# FLOOD RISK ASSESSMENT AND DRAINAGE STRATEGY ADDENDUM REPORT

DATE:	15 November 2023	CONFIDENTIALITY:	Confidential
SUBJECT:	Flood Risk Assessment Addendum Report		
PROJECT:	70084844	AUTHOR:	JM
CHECKED:	BB	APPROVED:	KM

WSP has prepared this Flood Risk Assessment and Drainage Strategy Addendum report on behalf of Vistry Homes in order to address comments received from the LLFA (23.10.12.H258.16.LLFA) on the previously submitted Flood Risk Assessment and Drainage Strategy document, also prepared by WSP.

*Figure 1. Flood Risk to Proposed Pumping Station – Located within Flood Zone 1*

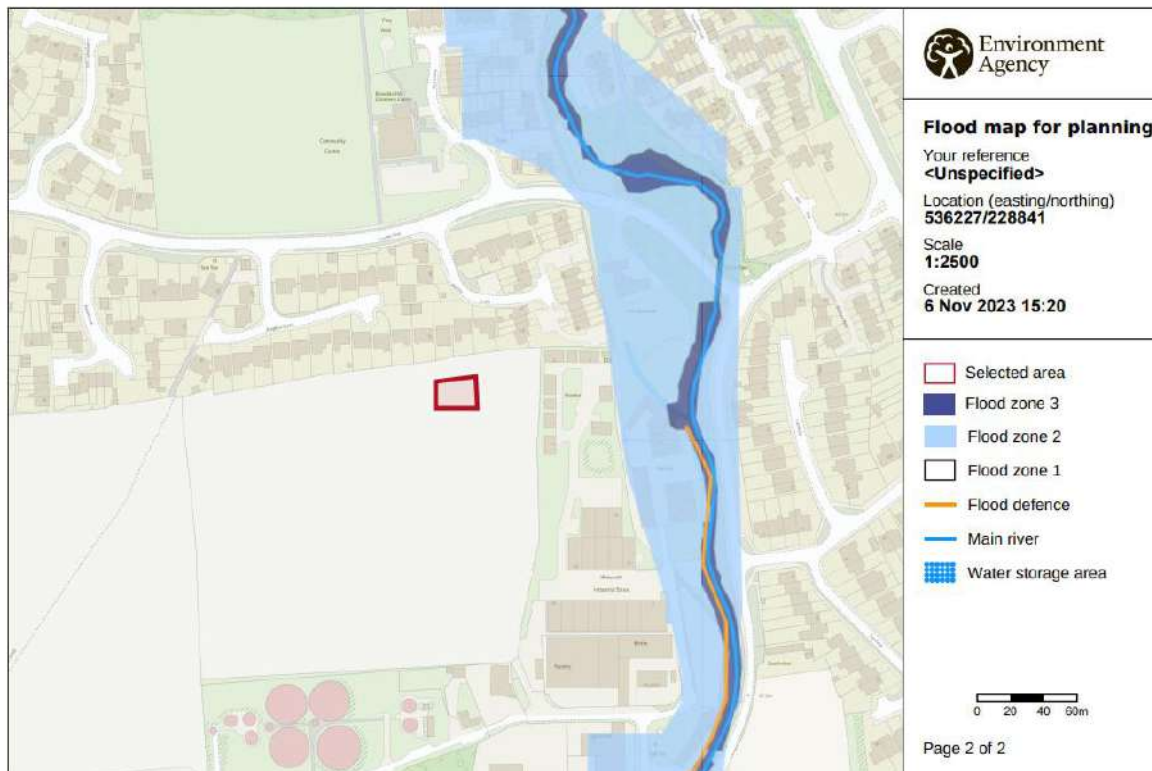
- Comment:** Surface water pumping stations should only be used where there is no other practicable sustainable method of surface water drainage, and an adequate exceedance flood route is provided in the event of failure of the pumping station. Any pumping station should be designed in accordance with the latest Design and Construction Guidance (DCG). A safe and reasonable vehicular access should be provided to the pumping station at all hours for the purpose of repair and maintenance. The relevant storage provision should be provided as indicated in the DCG to account for the residual risk of the pump breaking down. The surface water flooding outline shown on the Environment Agency

*mapping is close to the location of the pumping station. This should be taken into account as described in the DCG document.*

The proposed location is also sited within Flood Zone 1 as per EA Flood Map for Planning (refer to Figure 1) and is therefore site within land that has less that 0.1% chance of flooding per year, satisfying the requirement to not be located where it might be susceptible to flood at a frequency of 1:30 years.
